New Albany Architectural Review Board
Monday, August 11, 2025 Meeting Minutes - Approved

FDP-57-2025 Nationwide Children's Hospital Final Development Plan

**Architectural Review Board Staff Report
August 11, 2025**

**NATIONWIDE CHILDREN'S HOSPITAL – NEW ALBANY CLOSE TO HOME
FINAL DEVELOPMENT PLAN
CERTIFICATE OF APPROPRIATENESS**

Plan Enlargements

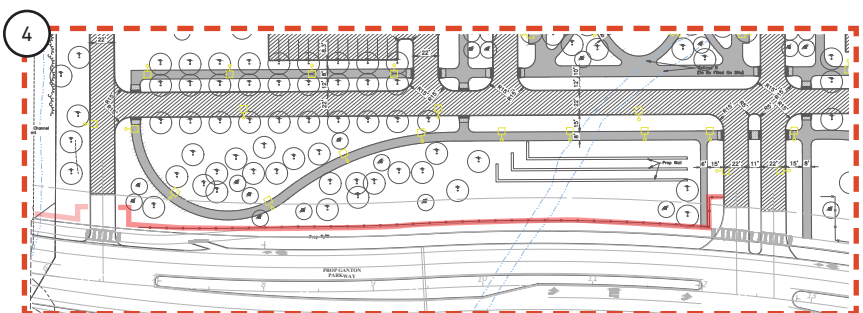
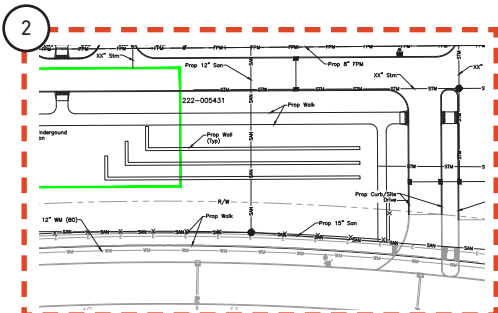
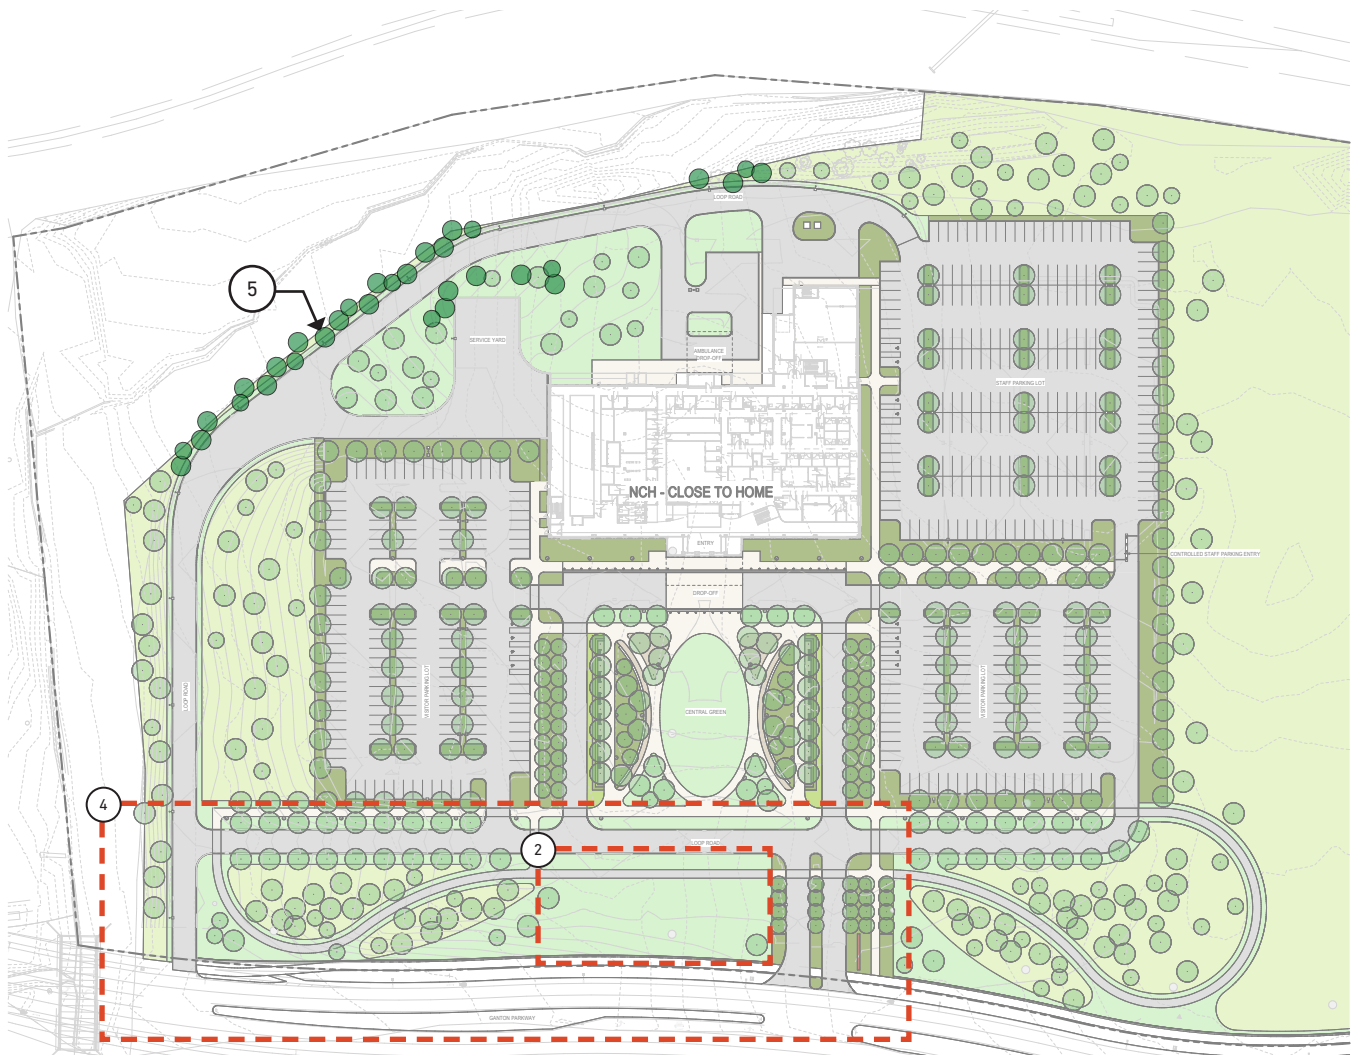
- 1. Color(s) of the proposed vehicular and pedestrian light fixtures outlined on sheet E al.
Per Ganton C-PUD Zoning District Part III, Subarea 1 Development Standar
light poles shall be black or New Albany green and constructed of metal.
- 2. Proposed wall c wn on shee al. If the proposed wall(s) are to remain,
update the plan to include details on the material and height of the wall(s). See diagram below.
- 3. Update the proposed site plan to include bicycle parking at a ra cle) hitches to every 100 vehicular
parking spaces.
- 4. Revise the fence at the west drive access to match the proposed c t the main drive along Ganton
Parkway. See diagram below.

- 5. Update the proposed plan ees to properly screen the outlined
service area. See diagram below.
